U. S. ATOMIC ENERGY COMMISSION

REPORT TO ADVISORY COMMITTEE ON REACTOR SAFEGUARDS

INDIAN POINT NUCLEAR GENERATING UNIT NO. 2

REPORT NO. 3

FIGURE 1

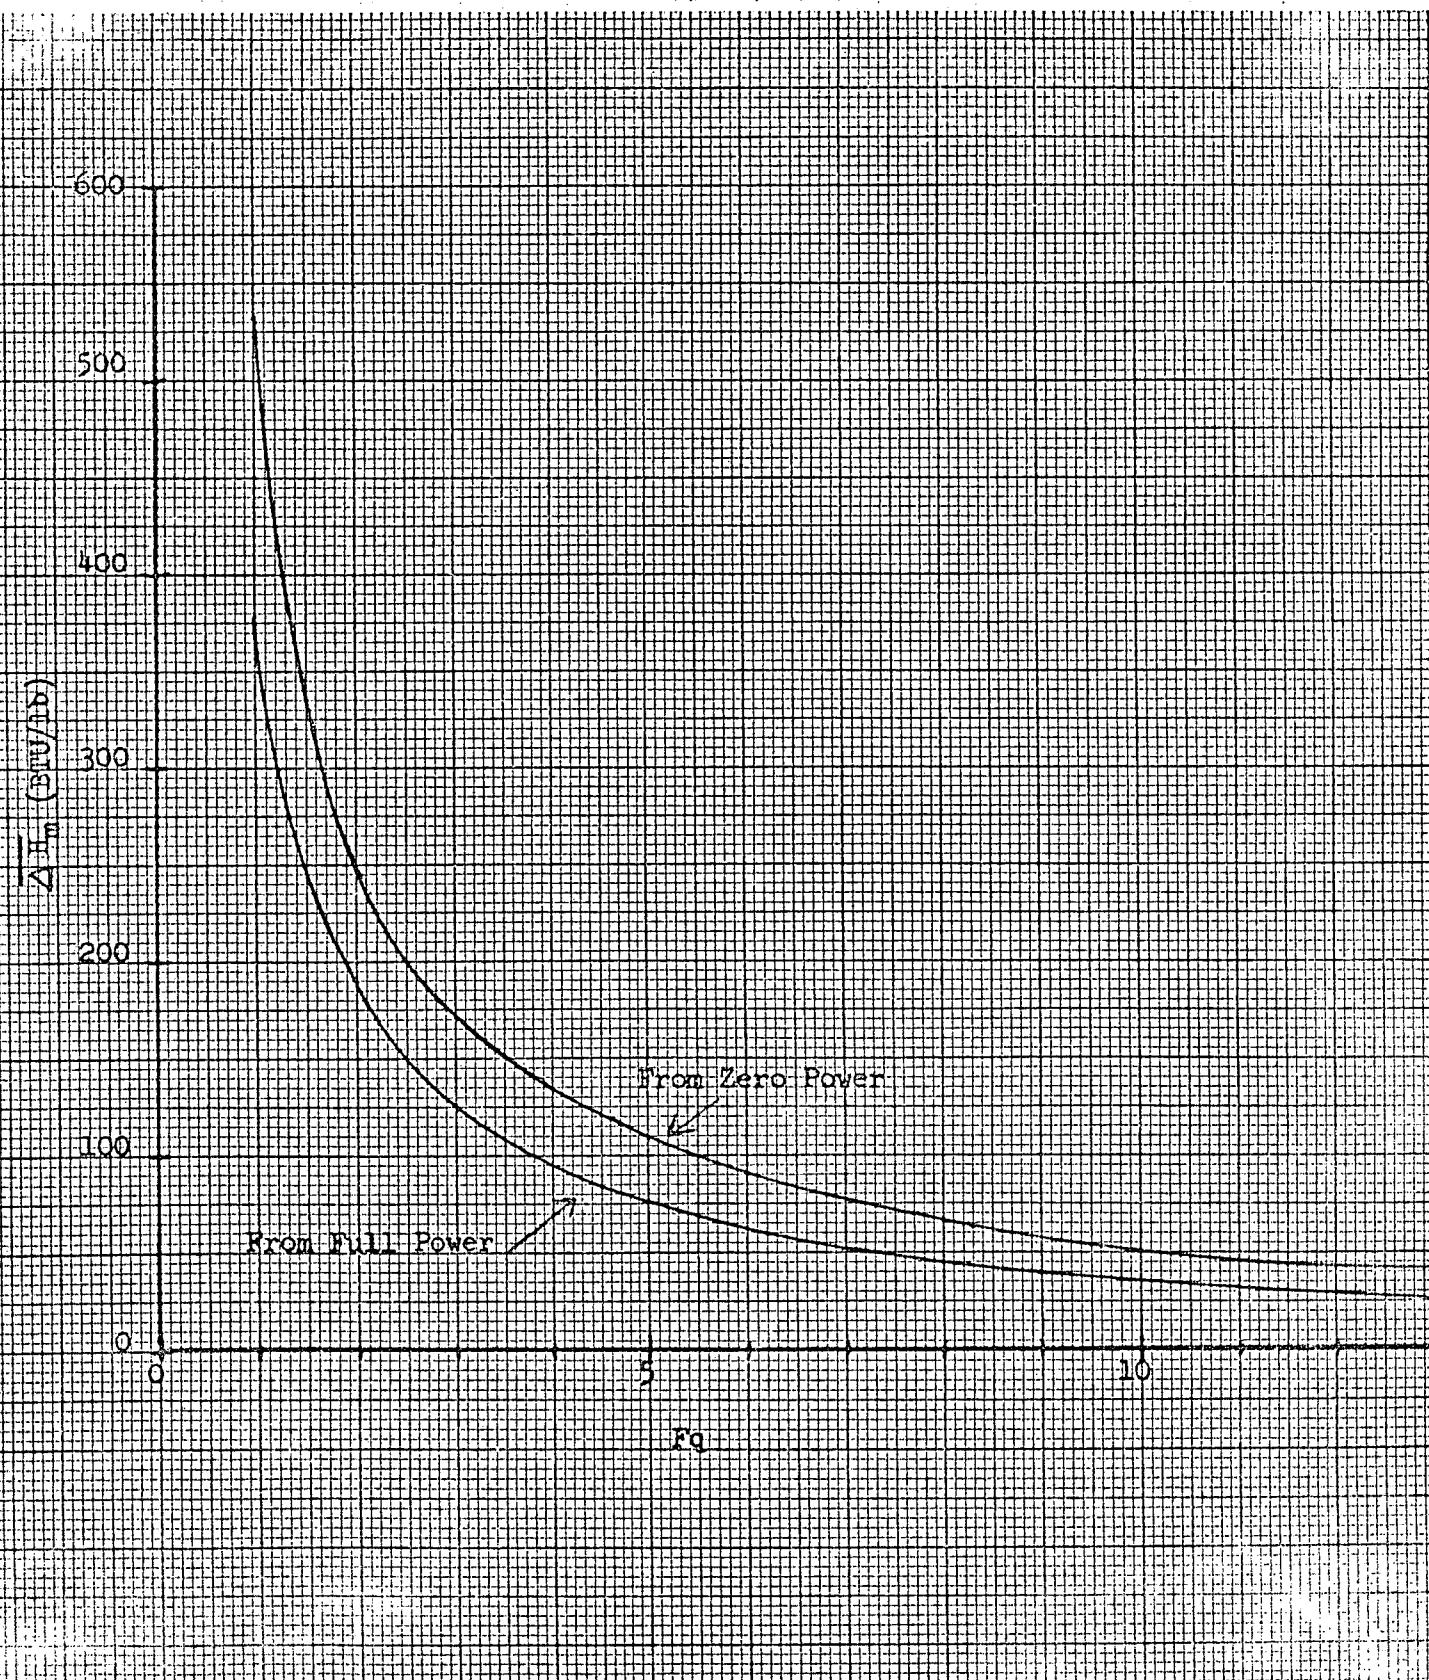
Where  $\bar{H}$  is either  $\bar{H}_o$  or  $\bar{H}_f$ . The results are given graphically in Figure 1. Of interest are the two low rod worth cases. From Table 1 we find that the full power case with a 0.5% rod ejection has an  $F_q$  of 6.3. Referring to Figure 1 we obtain a value of  $\Delta\bar{H}_m$  of 55 BTU/lb for this  $F_q$  on the full power curve. According to Table 1 we see that the computed value for  $\Delta\bar{H}$  is 55 BTU/lb indicating that for this case the average fuel in the hottest pellet is, for all practical purposes, fully molten. This result has been verified in subsequent discussions with the applicant. They indicate that for the 0.5% rod ejection case the center of the hottest pellet has vaporized and the volume averaged enthalpy is 550 BTU/lb. For the low rod worth case (0.8% from zero power) using a value for  $F_q$  of 8.3 we find from Figure 1 that  $\Delta\bar{H}_m$  is 65 BTU/lb. The value of 35 BTU/lb given in Table 1 as the resulting  $\Delta\bar{H}$  for this transient indicates that there is more margin to fuel melting in this case. These results are used in the following discussion of the applicant's sensitivity study.

FIGURE 2

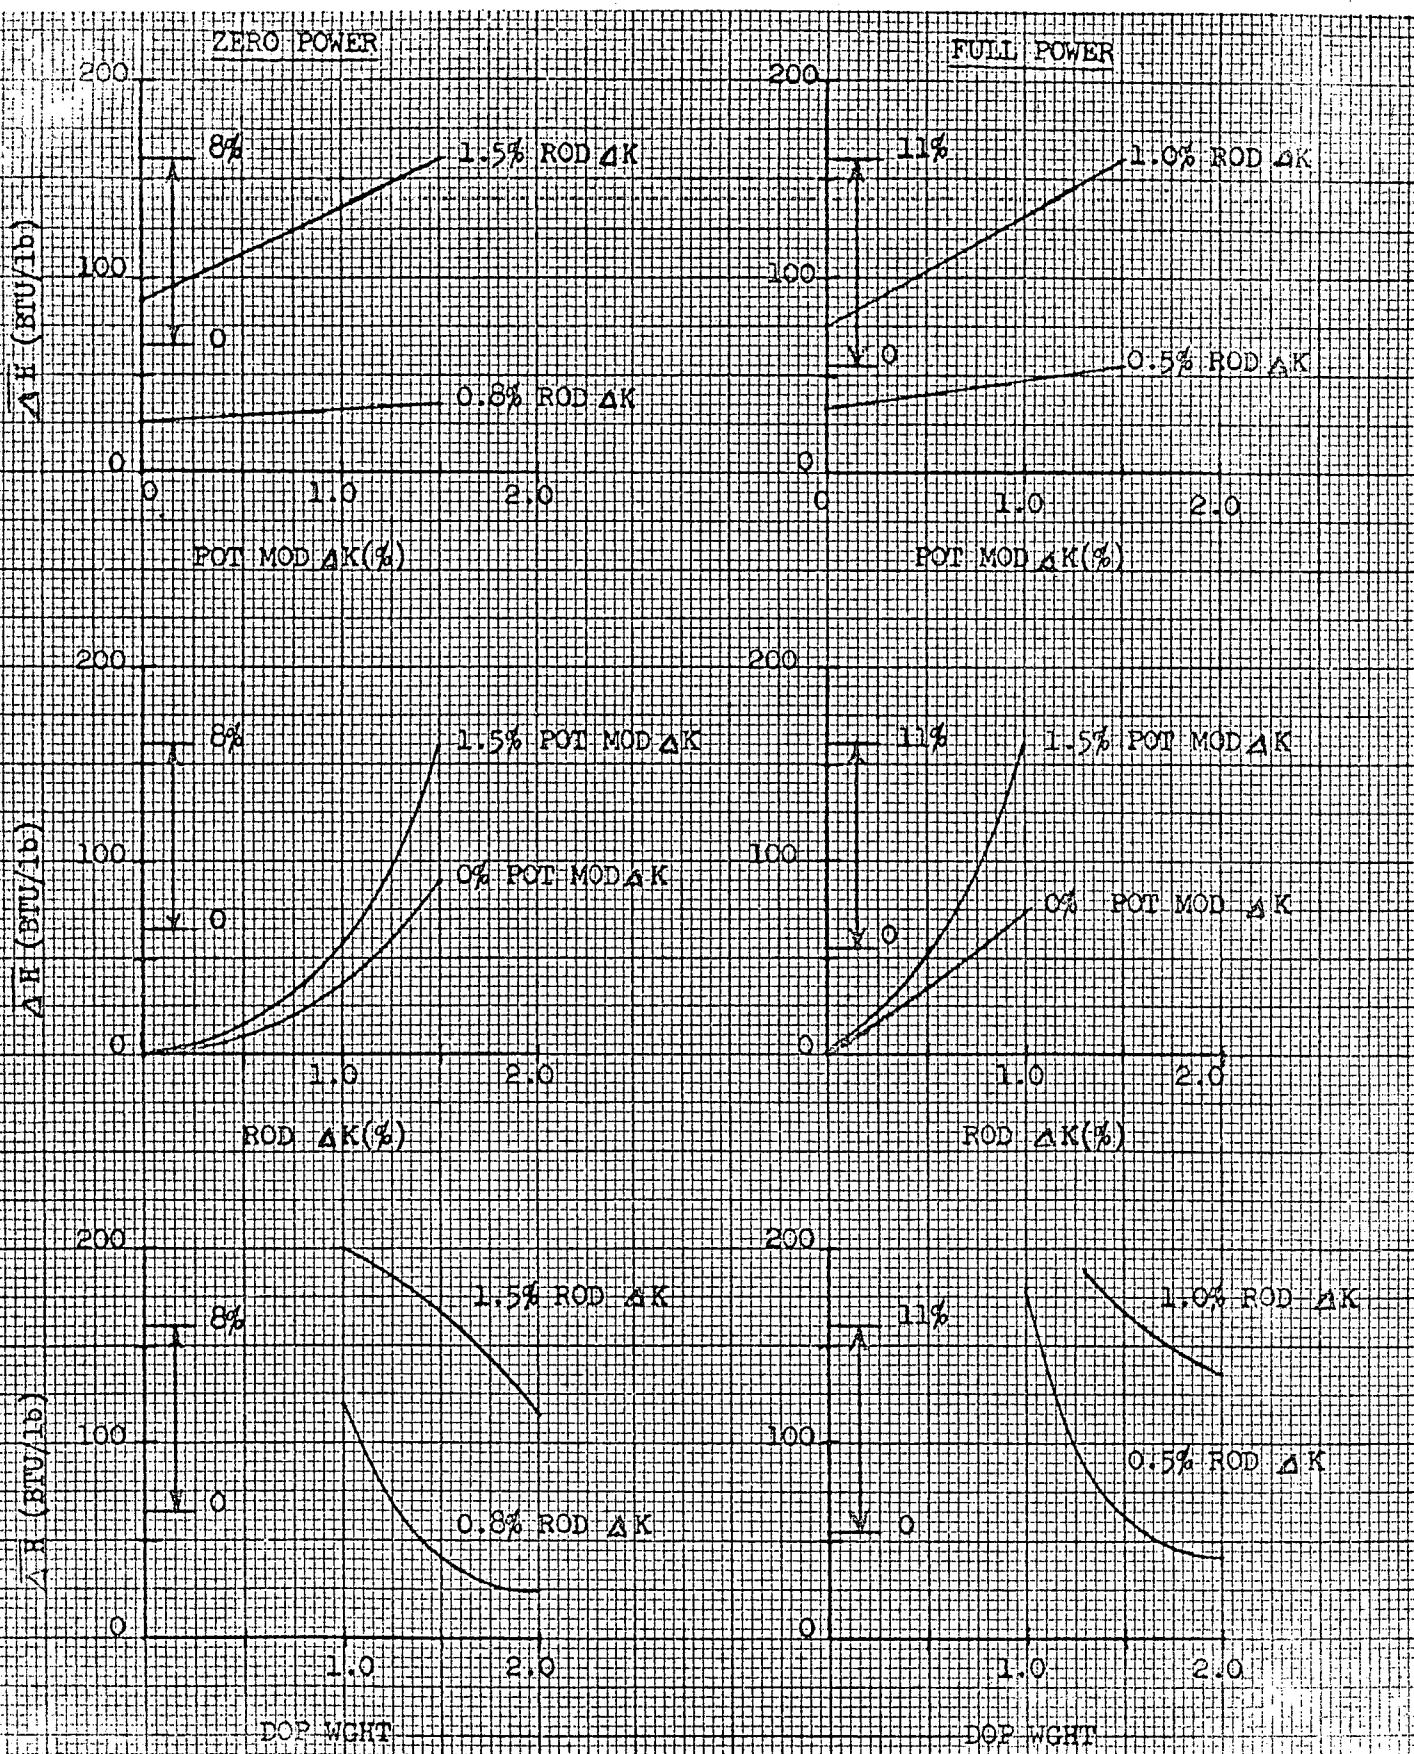
In Figure 2 we have attempted to show graphically the effect on  $\Delta\bar{H}$  of variations in three of the more significant fundamental parameters. The other parameters discussed in WCAP-2940 were shown there to have either a smaller effect

The three sets of curves on the left side of the page are for transients starting from zero power and those on the right for transients starting from full power. Two curves are given in each figure providing a second variable for consideration. Rod worth is used in the upper and lower sets and potential moderator insertion in the middle sets.

Inspection of these curves reveal several significant features. The upper two sets show that substantial fuel melting would probably occur for both high rod worth cases even with a zero potential moderator reactivity insertion. Again we note that these rod worths are not considered credible during normal operation. The moderator coefficient has a relatively slight but not insignificant influence on  $\bar{\Delta}H$  in the low rod worth cases. The difference between a zero potential moderator insertion and the potential 1.5% insertion computed by the applicant is only 10 BTU/lb in the zero power case and 20 BTU/lb in the full power case. The ejected rod worth is a more sensitive parameter as indicated by the central sets of curves. As expected, the sensitivity increases rapidly as the rod worth value is increased beyond prompt critical. Note that the difference between a "little" molten fuel and 11% fully molten in the full power case is due to only a factor of 2 in ejected rod worth. We note from these graphs that an important effect of increasing the moderator coefficient (more positive) is to increase the sensitivity of  $\bar{\Delta}H$  to the ejected rod worth.

Figure 3 - Containment Pressure at Time of Completion of Metal-Water Reaction

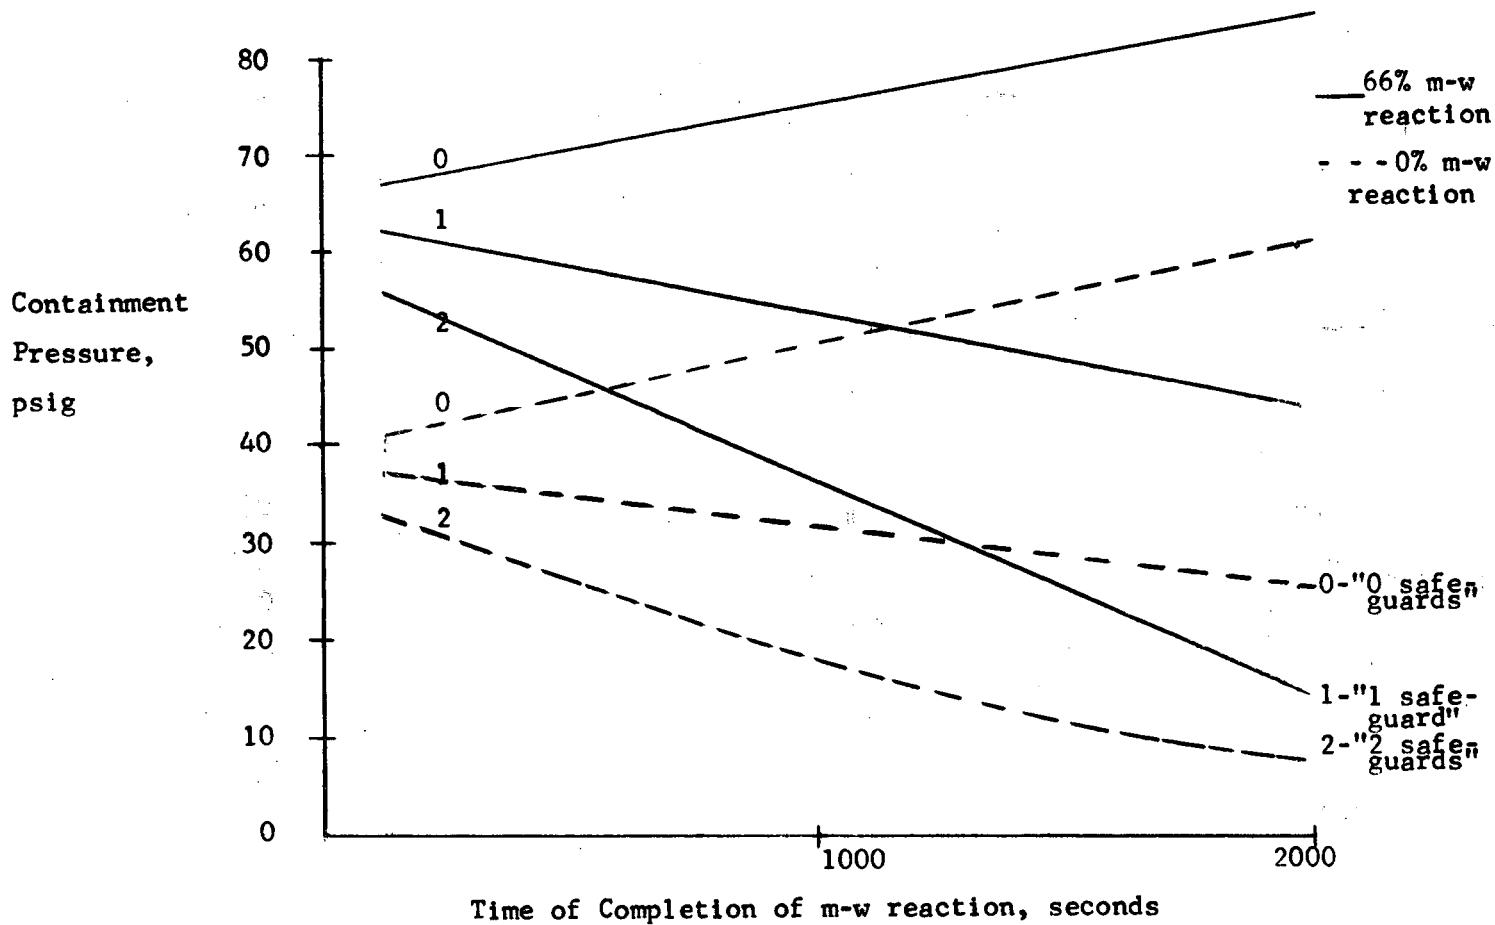
As an example, a 66% m-w reaction completed in 1000 seconds with 5 fan-coolers operating results in a containment pressure of 55 psig. The 0 line is significant as it indicates that with structural sinks only, the containment pressure increases with time due to the decay heat, original stored energy, and secondary coolant energy brought into the containment. It illustrates the importance of integrated core decay heat over long time periods.

One consideration not included in Figure 3 is the possibility of a hydrogen-oxygen reaction being delayed and then occurring all at once at the completion of the assumed m-w reaction. This would result in higher peak containment pressures with heat removal systems operating, since a lower pressure and lower water content would exist at the time of the delayed burning thus resulting in more effective superheating of the containment atmosphere.

Figure 4 - Effect of Hydrogen Burning on Containment Pressure

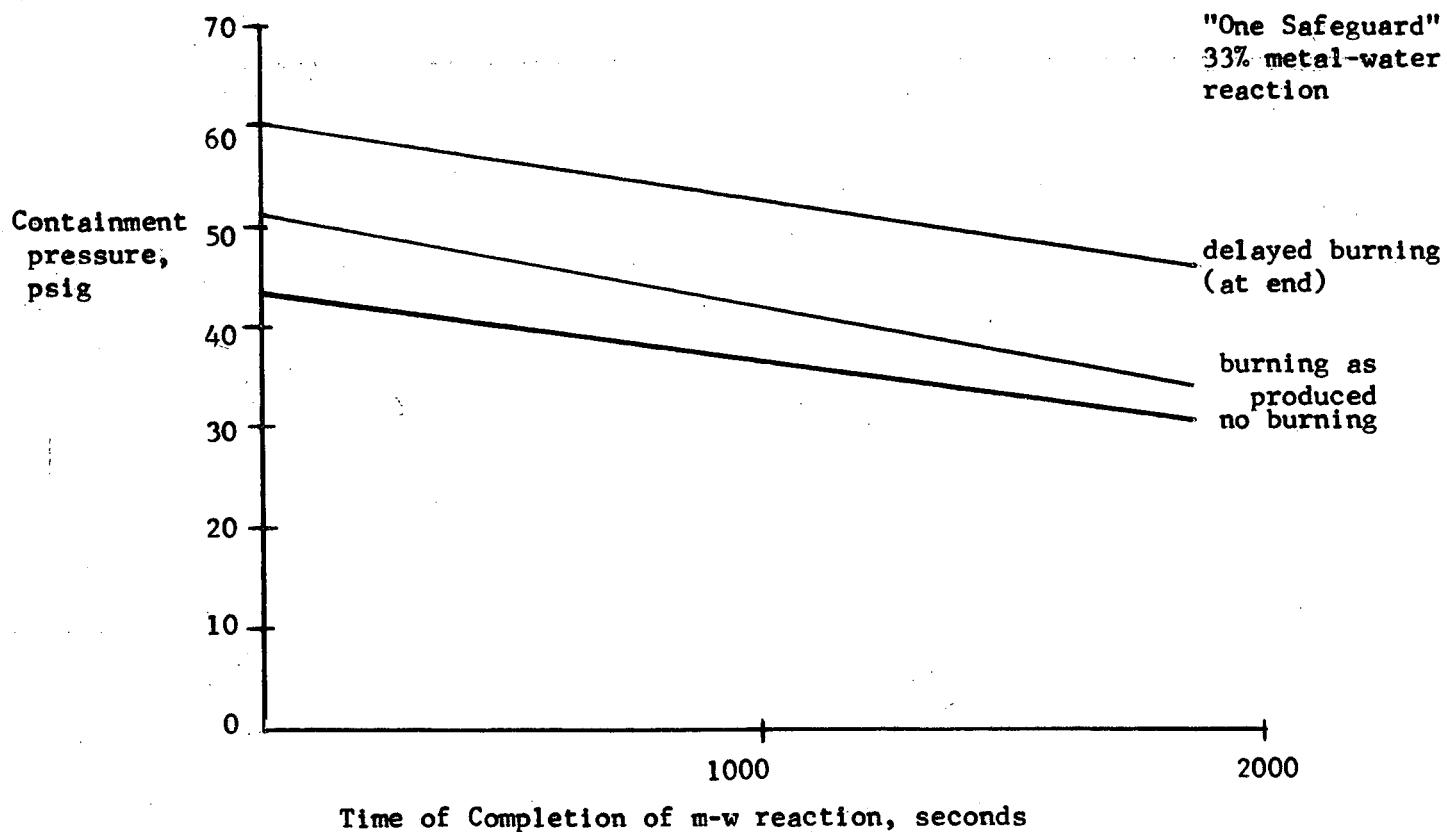
Figure 4 shows typical effects on containment pressure for the following 3 situations:

1. no hydrogen-oxygen reaction (hydrogen never burns),
2. hydrogen-oxygen reaction occurs as hydrogen is produced (the assumption used for Figure 3),
3. hydrogen-oxygen reaction delayed until completion of m-w reaction (there are numerous reasons which reduce this possibility).

Figure 5 - Allowable Metal-Water Reaction Without Exceeding Containment Pressures of 47 psig and 60 psig

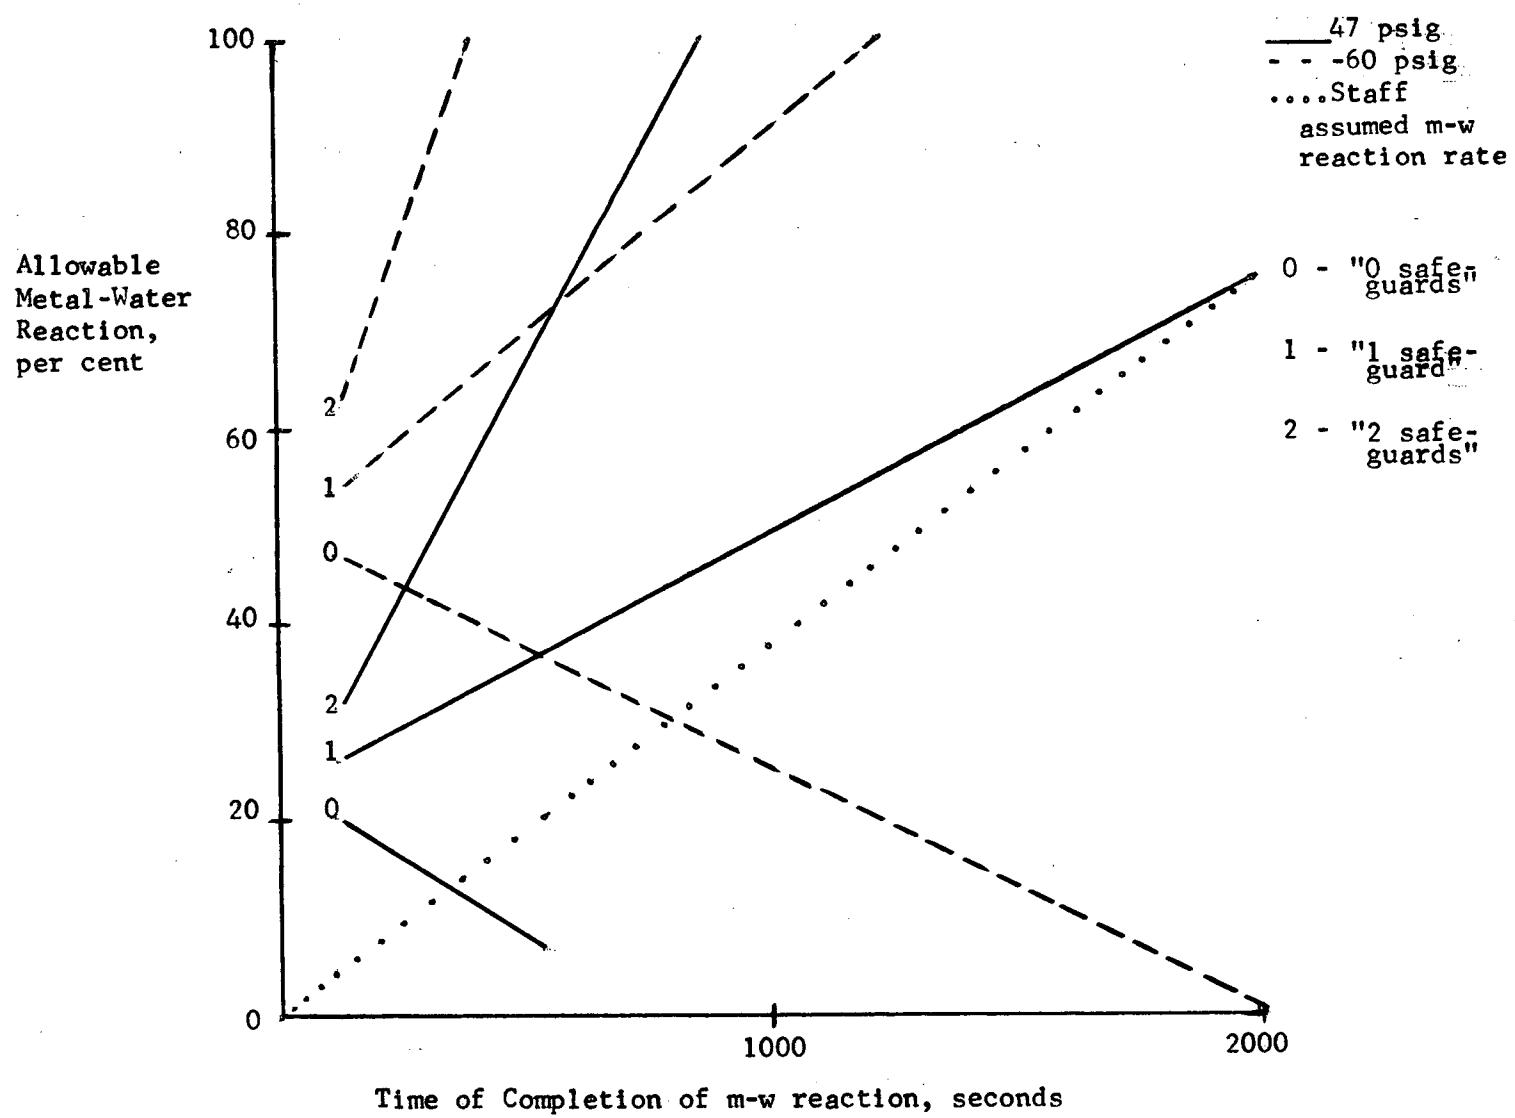
We have replotted Figure 3 indicating the allowable (or tolerable) amount of m-w reaction so as not to exceed the design pressure of 47 psig (solid line) and an additional arbitrarily selected pressure of 60 psig (dashed line). We believe this type of representation more clearly illustrates the containment capability and sensitivity to m-w reactions. As an example of its use, examination of

Figure 5 shows that at 1000 seconds with "one safeguard" operating a 50% m-w reaction is tolerable without exceeding 47 psig (80% is tolerable without exceeding 60 psig). The dotted curve of Figure 5 is the staff assumed m-w reaction model discussed previously and limited to a maximum credible total reaction of 75% in 2000 seconds. For comparison, the applicant calculated a maximum reaction of 43% to occur within 2300 seconds. We have therefore shown a linear reaction from 0 to 75% occurring in 2000 seconds. This results in our model predicting a 40% reaction in 1000 seconds which, for our example, is lower than the value of 50% allowable without exceeding the 47 psig design pressure. We would therefore conclude that the Indian Point 2 containment can tolerate m-w reaction at 1000 seconds greater than that which we would conservatively have predicted to occur.
